# CITY OF ALBUQUERQUE

RE: **Durango Subdivision, Units 3 - 5**  
**Tr H, Durango Unit 1 & Tr A Durango Unit 3A**  
**Drainage Report Stamp Date: 3/5/15**  
**Unit 3 Grading Plan Stamp Date: 8/12/15 (previously approved for Plat, 8/18/15)**  
**Unit 3A Grading Plan Stamp Date: 2/15/19**  
**Unit 4 Grading Plan Stamp Date: 8/12/15 (previously approved for Grading & Plat, 8/18/15)**  
**Unit 5 Grading Plan Stamp Date: 2/15/19**  
**Hydrology File: C09D012**

Based on the submittal received on 2/15/19 the above-referenced Grading Plans cannot be approved for Preliminary Plat, Grading Permit, and Work Order until the following are corrected:

Re: Durango Subdivision, Units 3 - 5  
Tr H, Durango Unit 1 & Tr A Durango Unit 3A  
Drainage Report Stamp Date: 3/5/15  
Unit 3 Grading Plan Stamp Date: 8/12/15 (Approved for Plat, 8/18/15)  
Unit 3A Grading Plan Stamp Date: 1/18/19  
Unit 4 Grading Plan Stamp Date: 8/12/15 (Approved for Grading, 8/18/15)  
Unit 5 Grading Plan Stamp Date: 1/18/19  
Hydrology File: C09D012

DURANGO  
UNIT 3A  
GRADING AND DRAINAGE PLAN

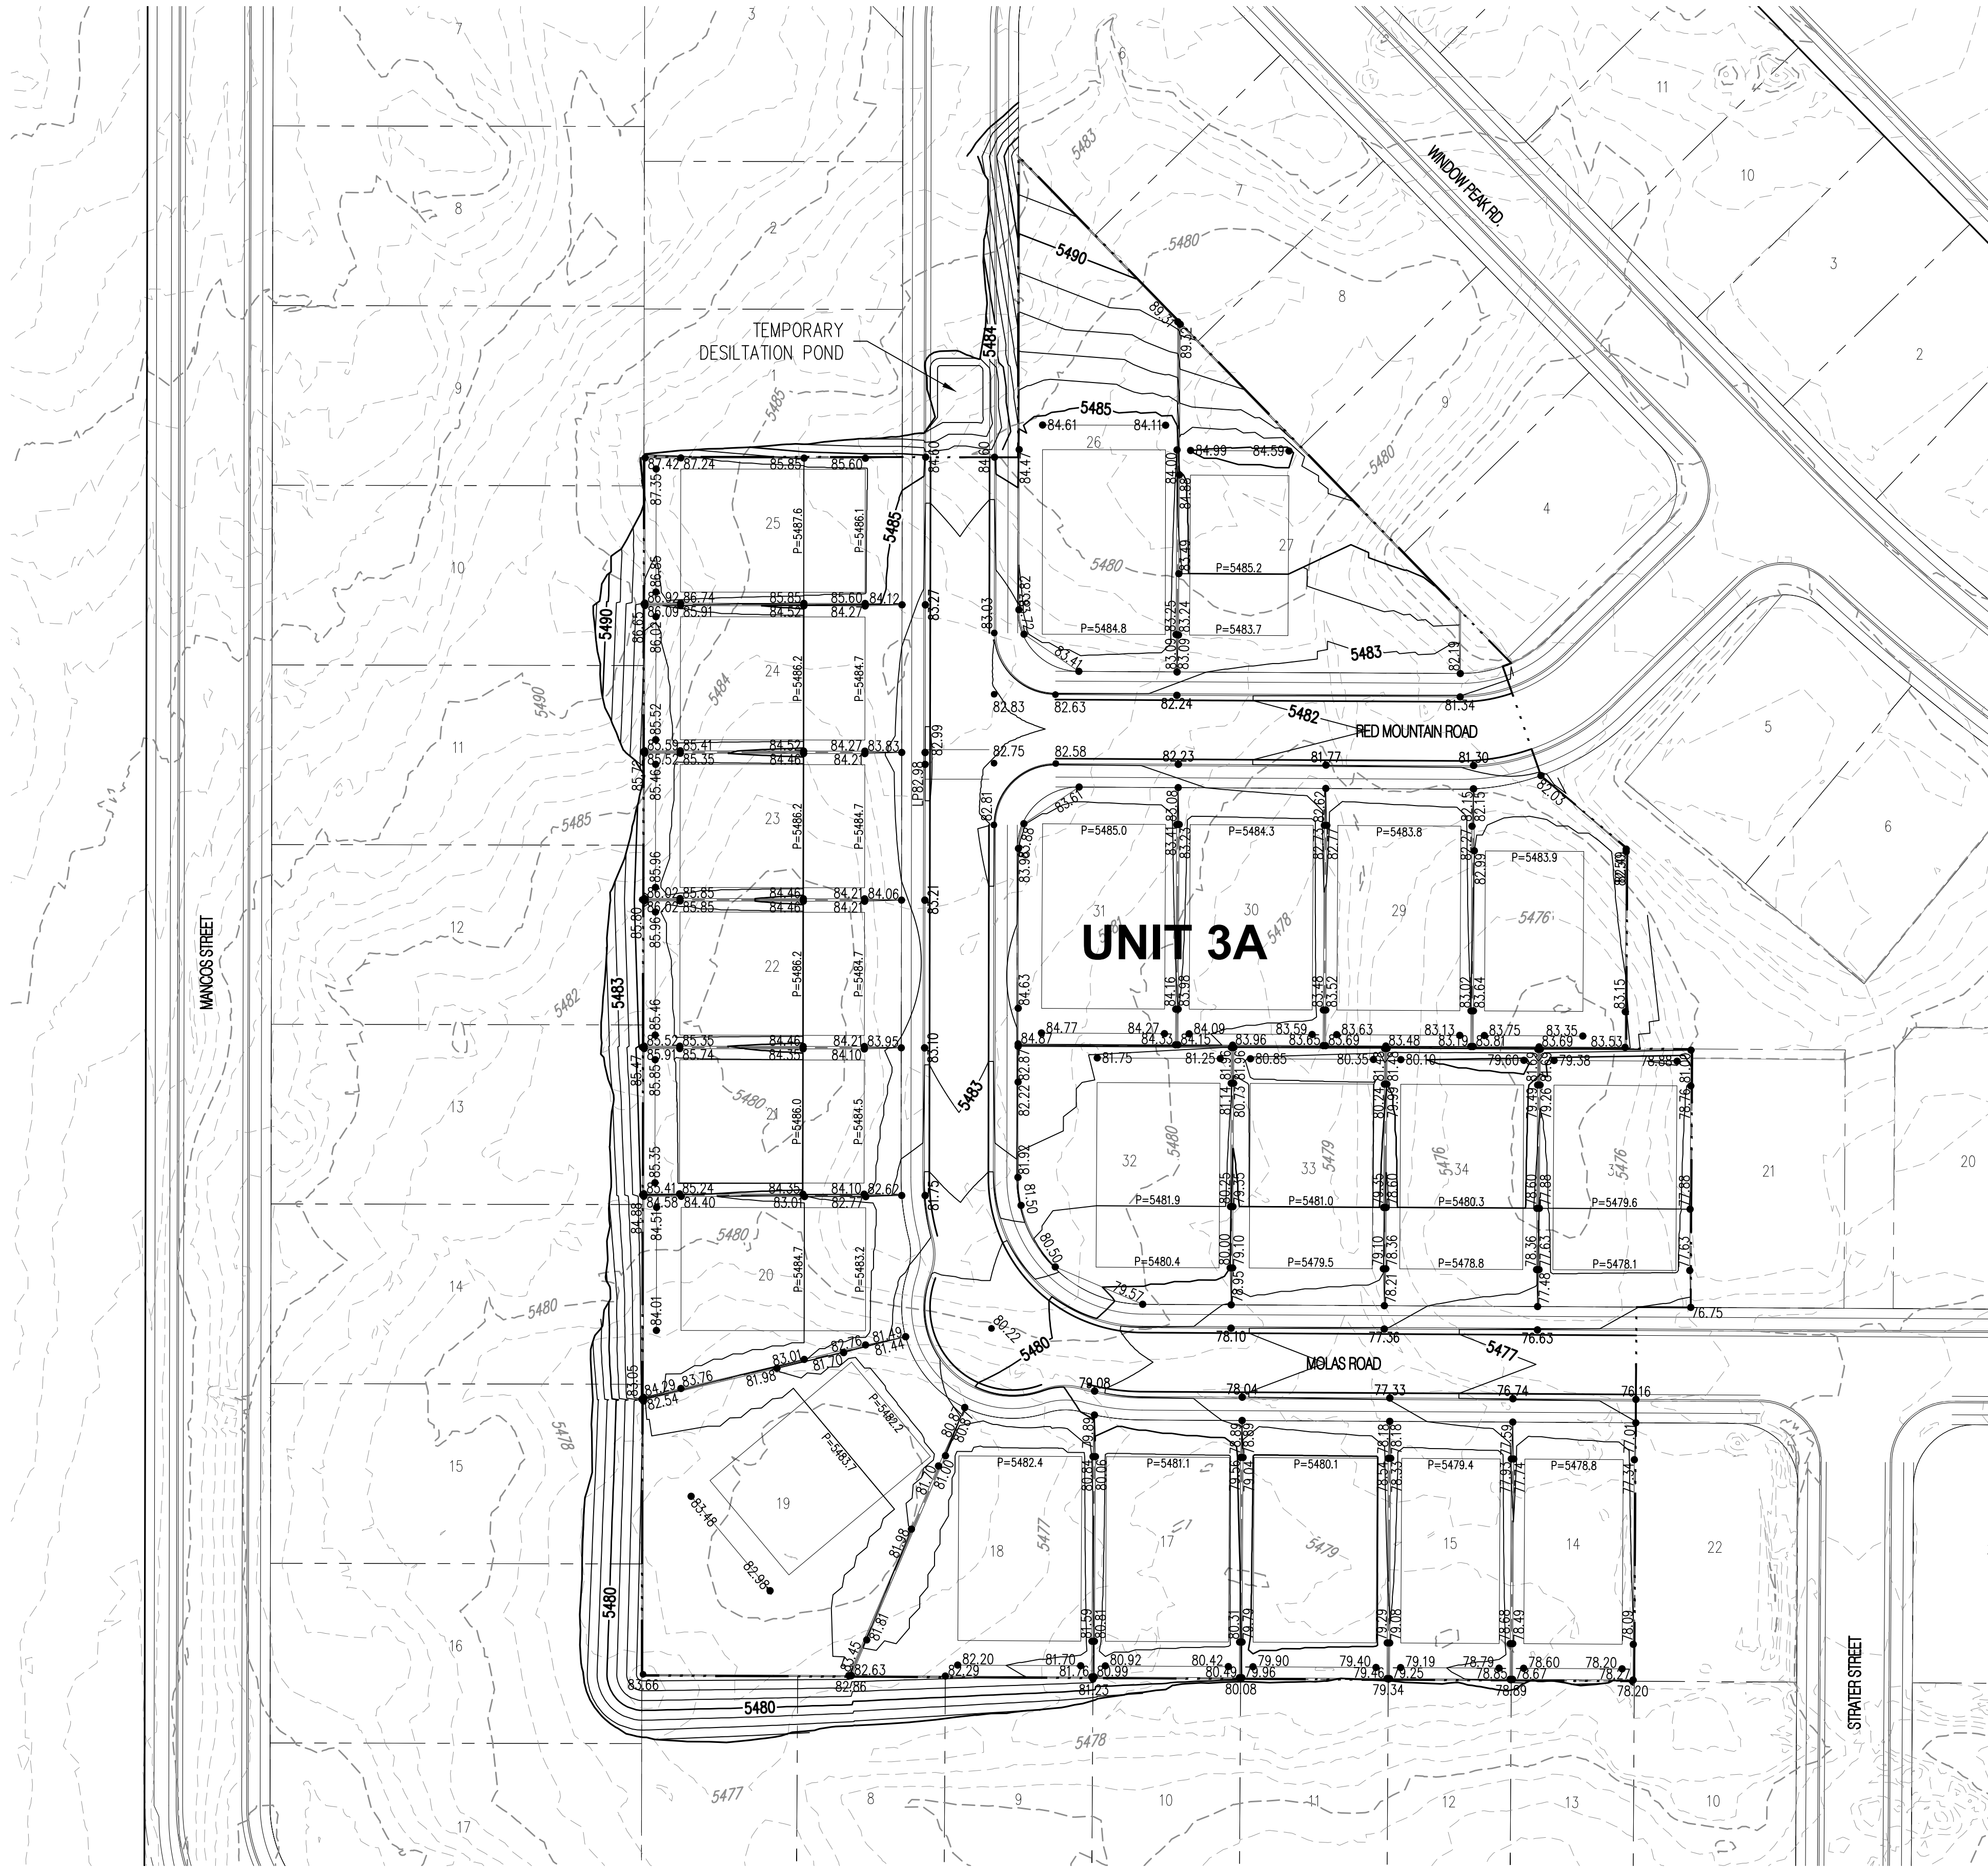
1. Show the storm drain network on the Grading Plan (vicinity of Unit 3A, layer may be missing or turned off); delineate which portions have been constructed (any portion of the storm drain that hasn't been constructed and accepted will need to be added to the infrastructure list).

2. How will flows be directed from the west side of Coal Bank St to Red Mountain Rd (Unit 3A)? It appears that a valley gutter is needed here. (layer may be missing or turned off)

2. Show the storm drain network on the Grading Plan (vicinity of Unit 3A); delineate which portions have been constructed (any portion of the storm drain that hasn't been constructed and accepted will need to be added to the infrastructure list). **Storm drain has been added. No new storm drain is needed**

5. How will flows be directed from the west side of Coal Bank St to Red Mountain Rd (Unit 3A)? It appears that a valley gutter is needed here. **Valley Gutter has been added.**

**DURANGO  
UNIT 3  
GRADING AND DRAINAGE PLAN**

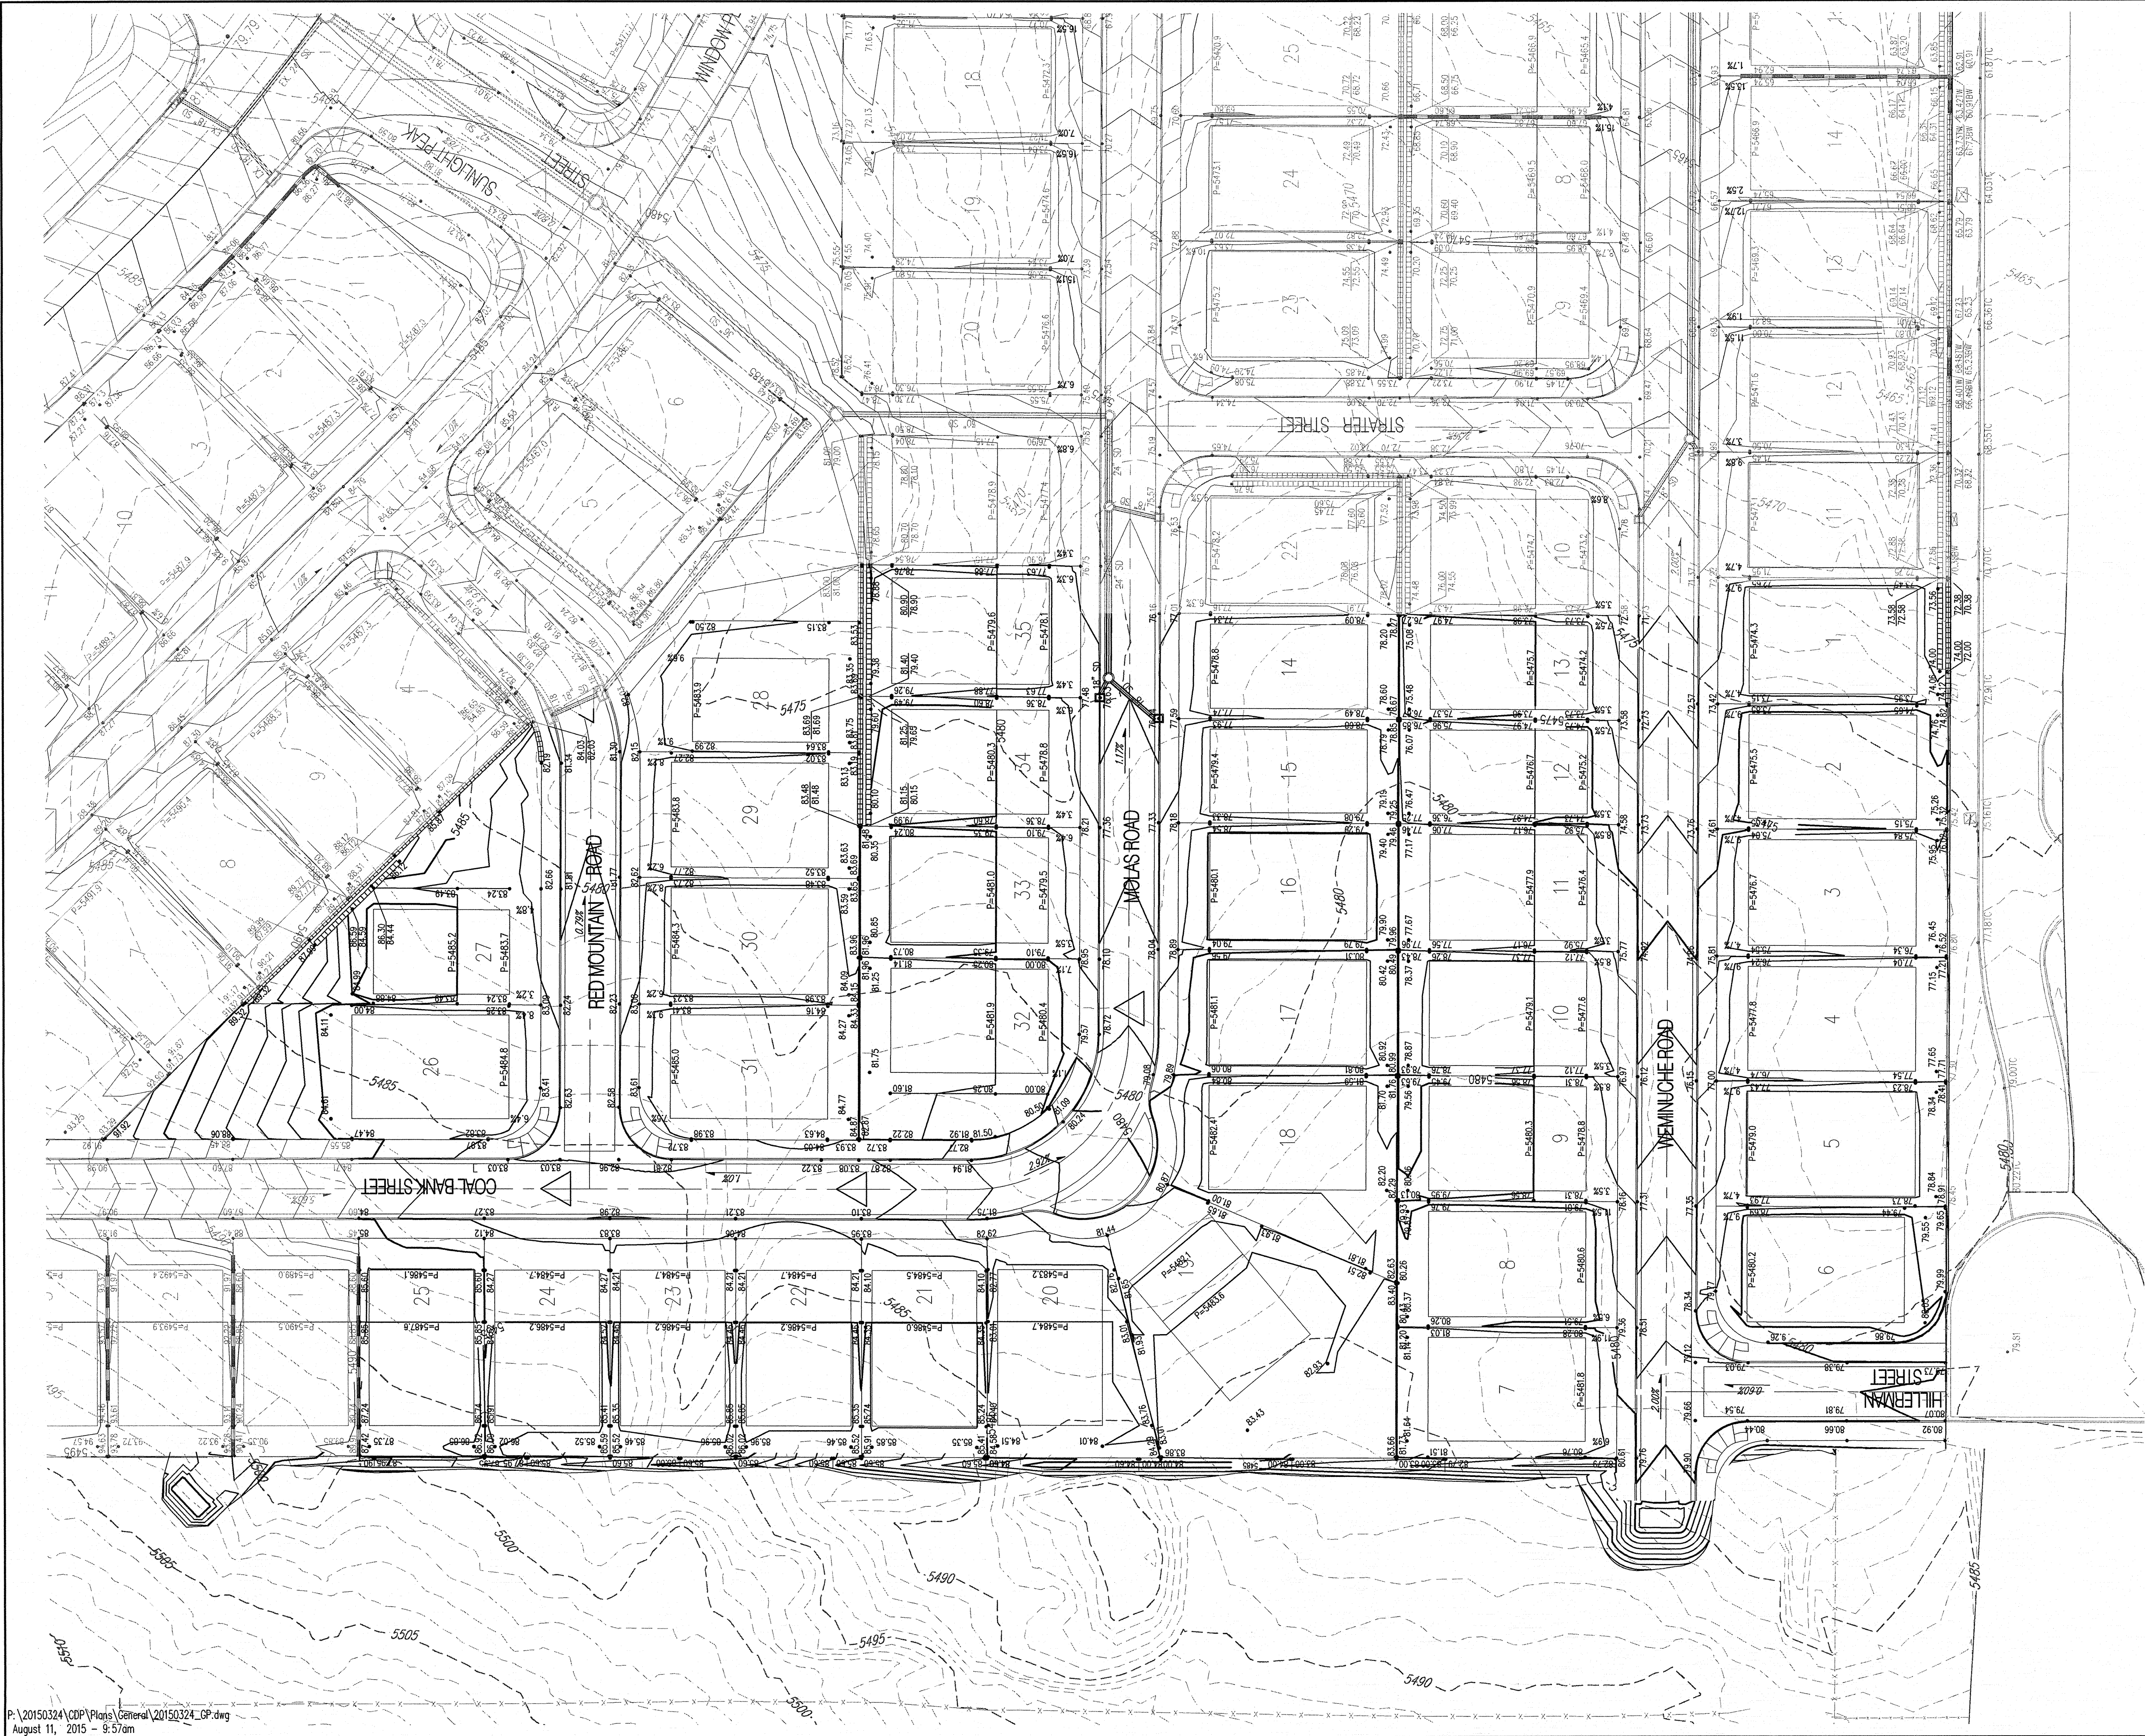
RE: **Durango at the Trails (File: C09D012), Unit 3**  
**Grading and Drainage plan, Stamp Date 8-12-15 (Sheet 4)**

1. An Interim Grading Plan is required showing a temporary pond on Coal Bank Street where Unit 4 ties in. Temporary Drainage Easements will be required before Work Order Acceptance.
2. Items that need to be addressed on the Work Order:
  - a. It appears a valley gutter is needed to direct flows from west side of Coal Bank St. down Red Mountain Road.
  - b. Offsite runoff seems to be directed by a swale to run behind the lots down to Weminuche Road. The sediment pond should pick up those flows.
